STAFF REPORT

To: Edgerton Planning Commission
Fr: Kenneth A. Cook, Community Development Director
Re: Application FS2016-03 for the Final Site Plan for Logistics Park Kansas City
Phase IV, Second Plat, Lot 4 (IP XXXIII)

Final Site Plans Logistics Park Kansas City Phase IV, Second Plat, Lot 4 (Inland Port XXXIII)

Sheet
C04

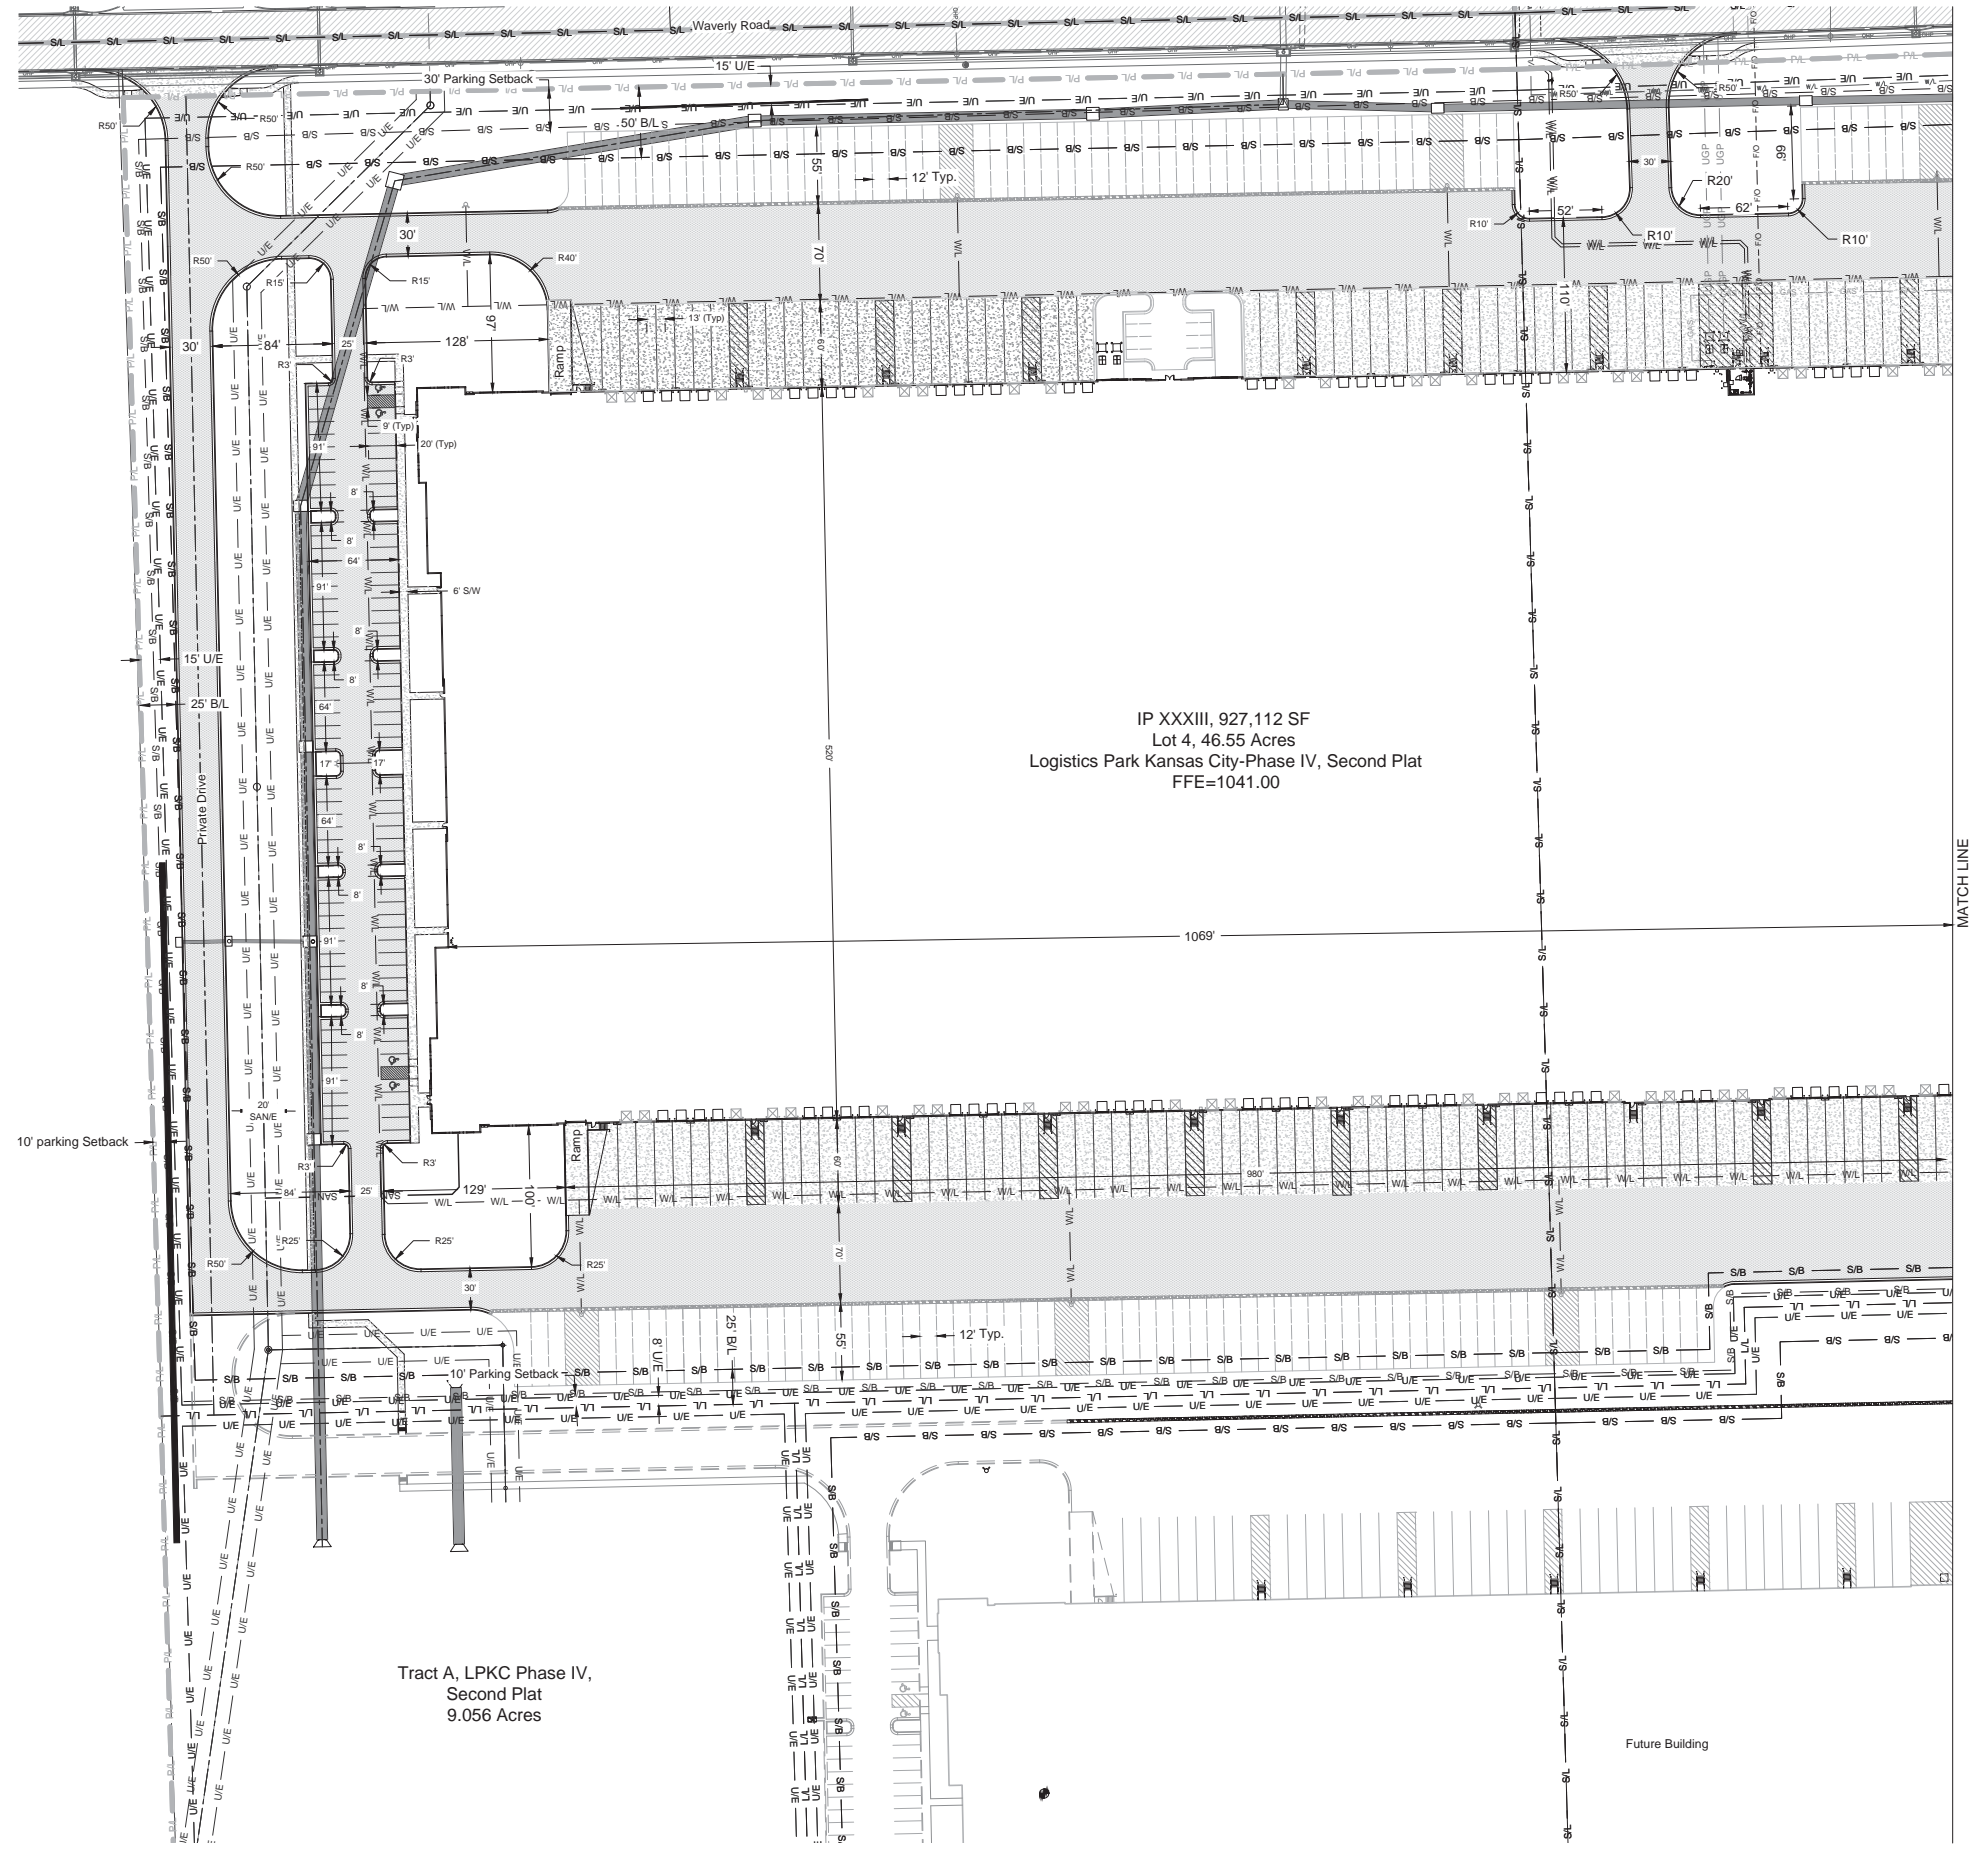
- iii) Location of buildings. ***Final Site Plan complies.***
- iv) Parking areas, paths, walks with sizes and surfaces material specifications. A *sidewalk should be included from the Southeast corner of the building to the public sidewalk so that individuals walking from Waverly Road don't have to walk through the grass or walk all the way down to the entrance at the Southwest corner in order to access the building. The sidewalk located across the Northern portion of this site should be included in a cross-access easement. Update Final Site Plan.*

- vi) Site entrance and connections to streets. *The site plans currently show four points of access for this site. The first access point is from the Southwest corner of the site. Three additional access points are shown along Waverly Road and are located directly across two of the proposed access shown on the IP XIV plan. The third of these entrances is located at the far Northeast Corner of the site and also provides access to Inland Port XXXII, which is located to the West of the subject property. The applicant has had discussions with staff which have included a modification to the Southwest access point and can be seen on the new exhibit which is attached to this report. This modification is to connect the driveway entrance of this Lot to the driveway on Lot 2. This connection would be made directly behind the Water Tower property. The Final Site Plans need to be updated to show the proposed changes.*

- vii) The location of easements. *An additional pedestrian easement is needed across the Northern portion of this property or the sidewalk could also be moved to be located in the cross access easement located on the Northern portion of the plat. Additional Utility Easements may also need to be shown as the gas and power lines that appear to serve the adjacent property to the West are not shown as being located in an easement. Update Final Site Plan.*

Sheet
L1

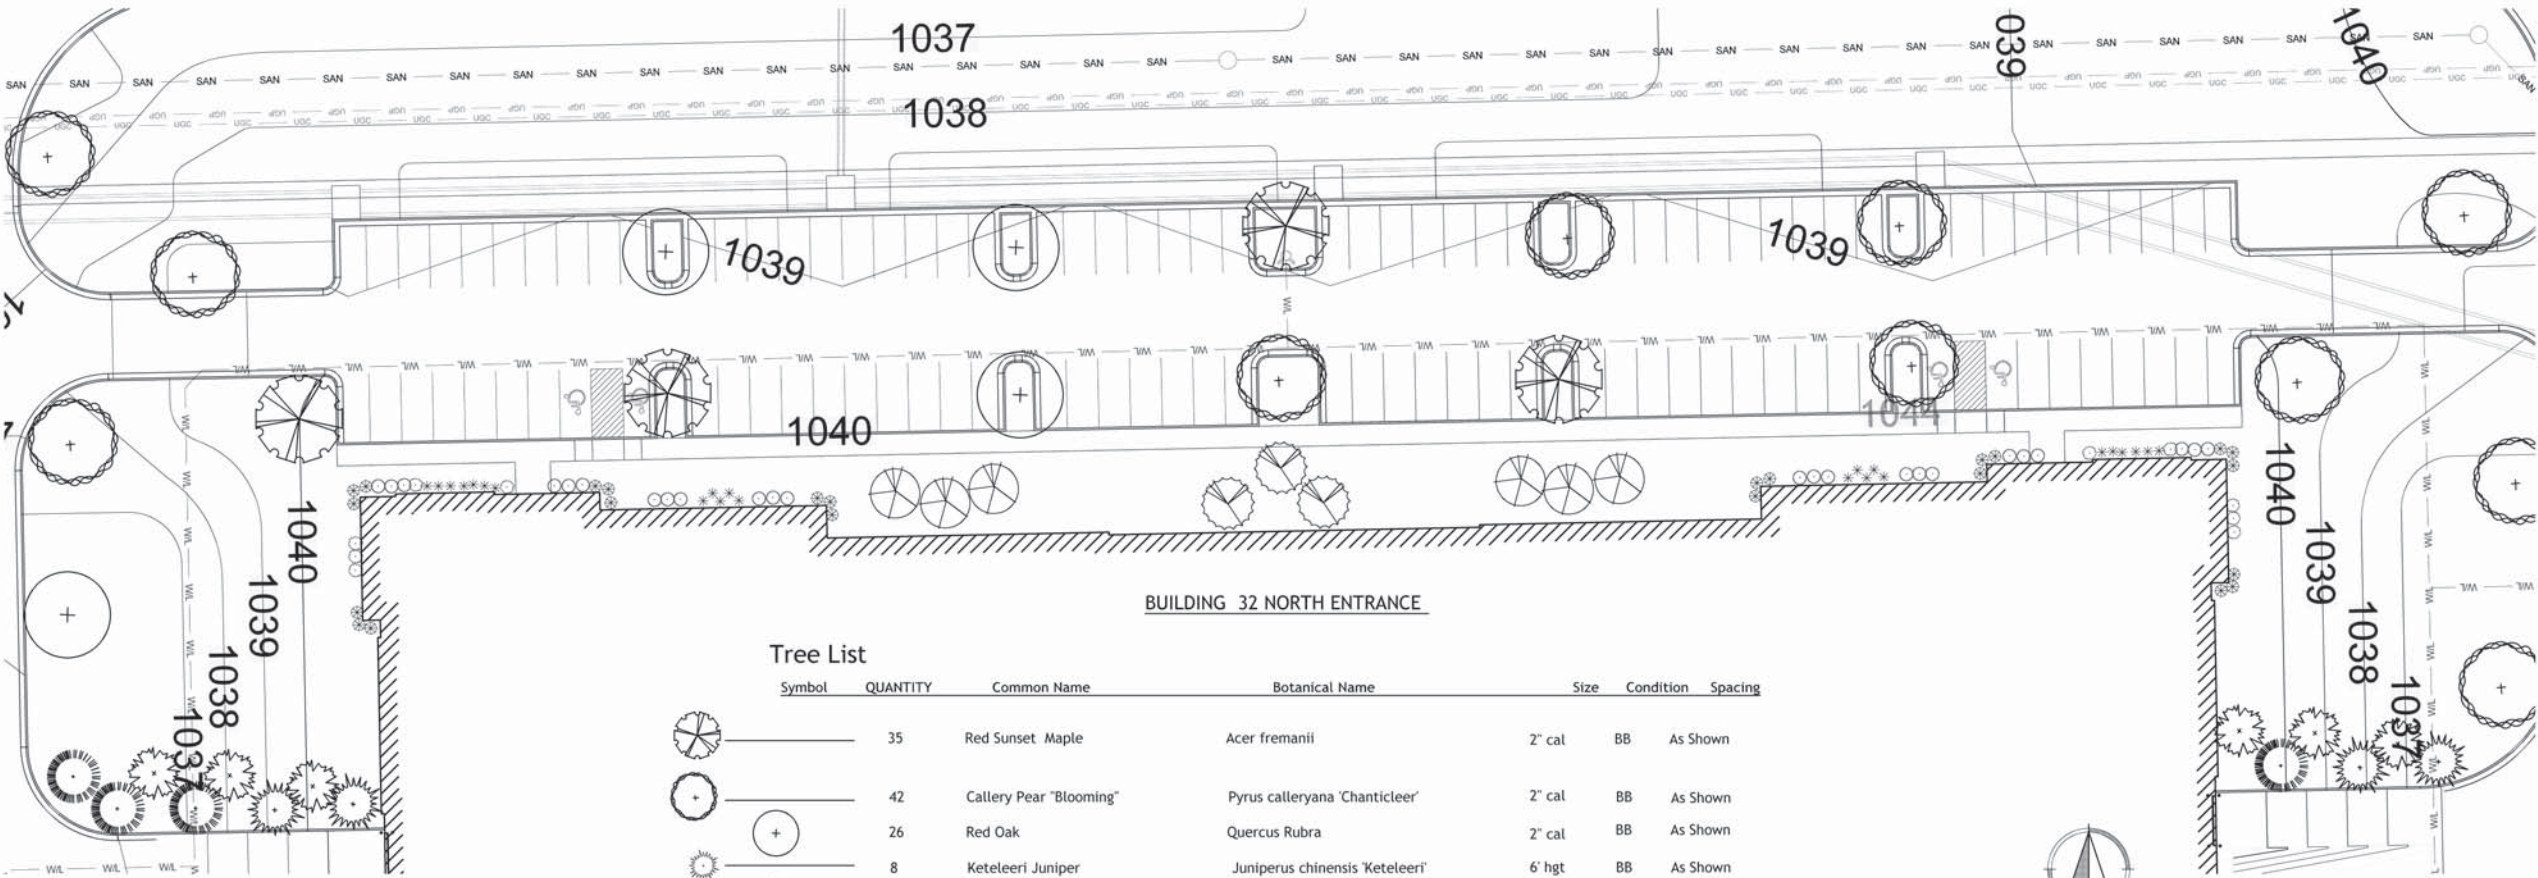
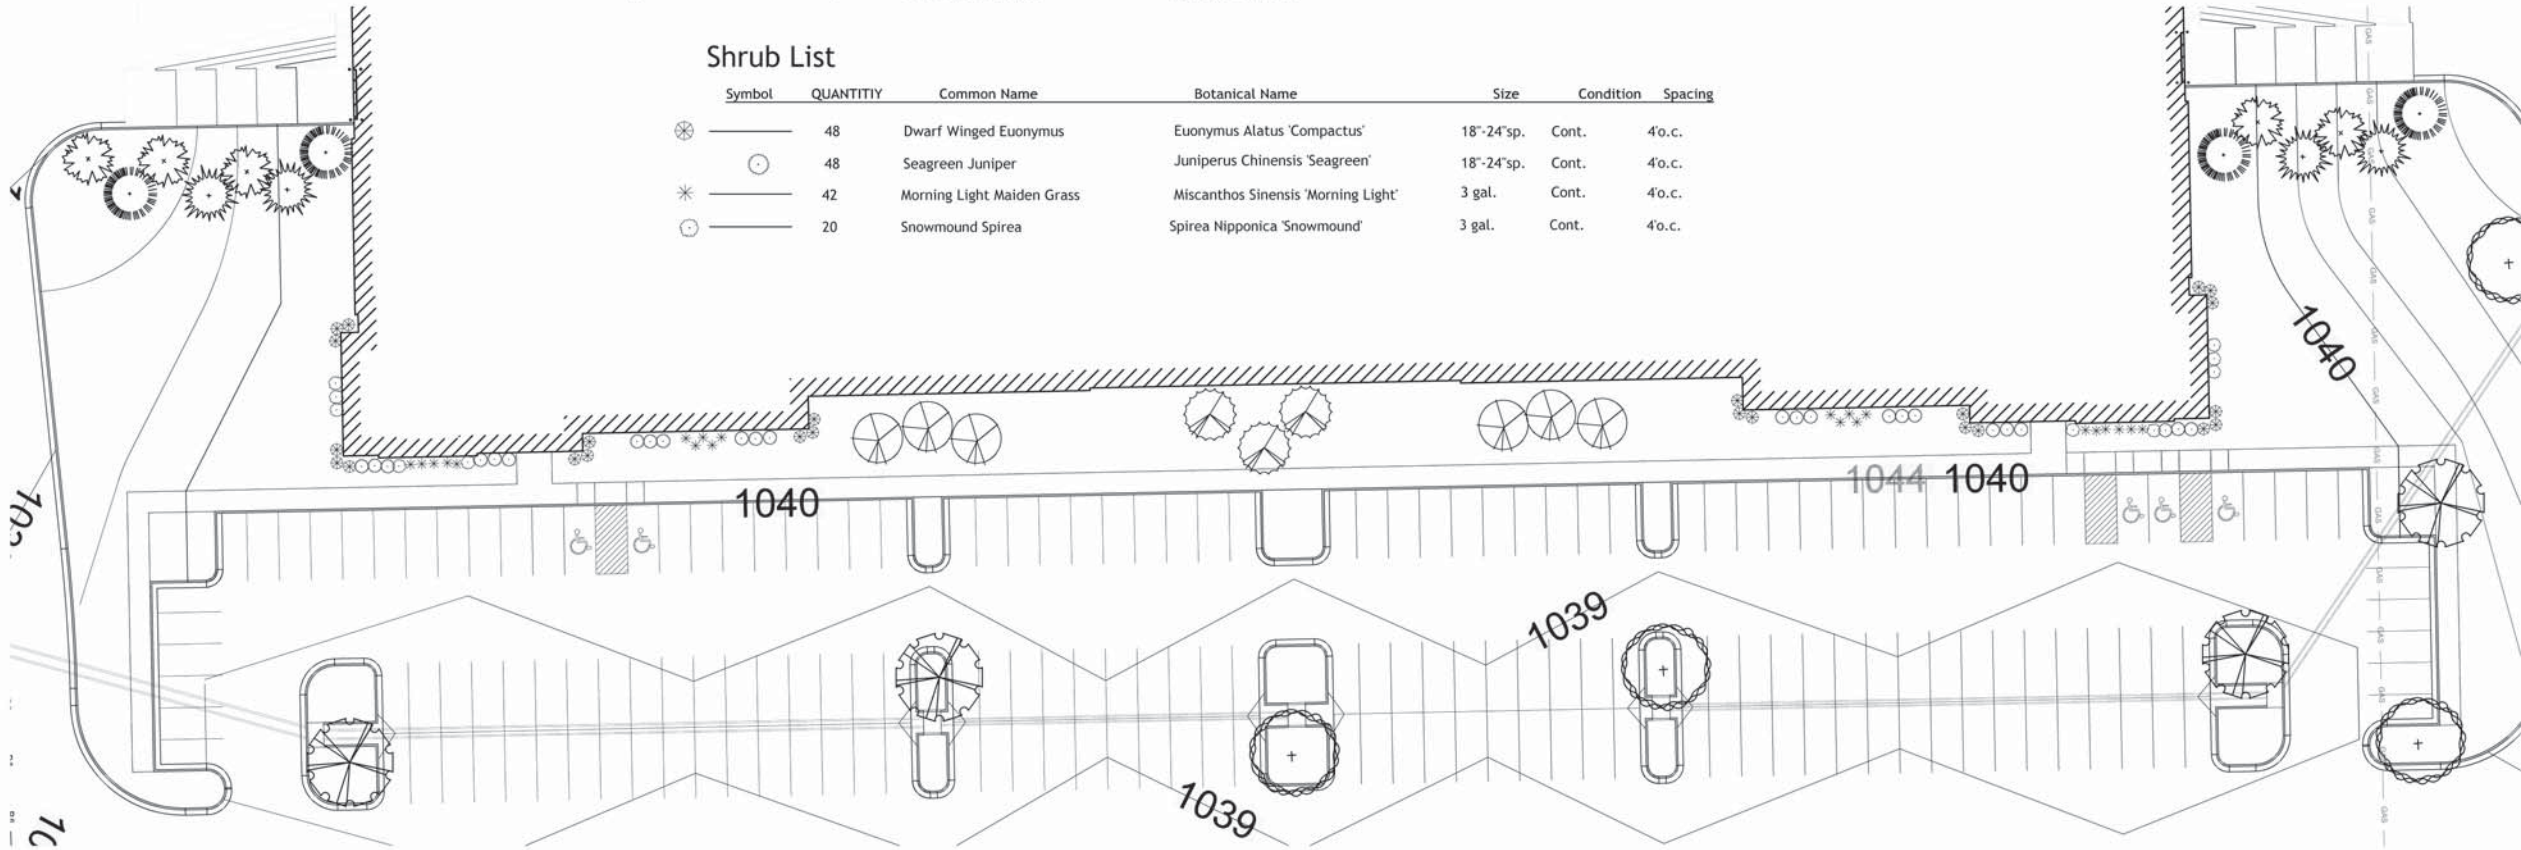
- a) A landscape plan drawn to scale, showing the site, building location, planting and seeding schedules, refuse and outdoor storage screening and boundary screening. All landscape features shall be shown in relation to sidewalks, paths, lawns, parking areas and drives. **Update Final Site Plan.**
 - *Trash containers and screening have not been shown.*
 - *A sidewalk connection should also be made from the Southeast Corner to Waverly Road*
 - *The title and some of the labels on the Landscape Plans currently specify Import 32 and should be updated to IP XXXIII.*
 - *The overall landscape plan also needs to have the building numbers updated to match the current scheme.*
- b) A table entitled "Planting Schedule" which lists the common name, size and condition of all planting materials, together with a timetable for planting. *No timeline for planting is included.*

3. The City may require that loading and service areas are screened from public view with landscaping, berming, facade walls, or fencing. *The orientation of the building exposes the East side containing dock doors and future trailer parking to visibility from a public right-of-way (Waverly Road). This building is proposed directly across the street from a similar building in which the Planning Commission allowed for the placement of these items adjacent to a ROW with the consideration of an Alternative Landscape Plan and discussion for the placement of additional Landscaping at entrances. **The Planning Commission can approve an Alternative Landscape Plan for the property which will take***

these concerns into consideration. Staff suggests that additional Landscaping be required to be placed at the entrances to the facility

1. Alternative Landscape Plan. In lieu of the requirements set forth in Section 1.1., Landscaping Standards, an Alternative Landscape Plan (ALP) may be submitted to the Planning Commission for approval. An ALP shall utilize an innovative use of plant materials and design techniques in response to the unique characteristics of a particular site. At a minimum, an ALP shall contain equivalent landscaping as is required by these regulations. *In general, the applicant has prepared a plan that is designed to be similar to the Landscaping that has been provided in other projects. Staff suggests that additional landscaping be provided at the entrances into the site as the normal standard would require shrubs spaced at intervals along the entire frontage of the property and back to the front of the building along side property lines.*
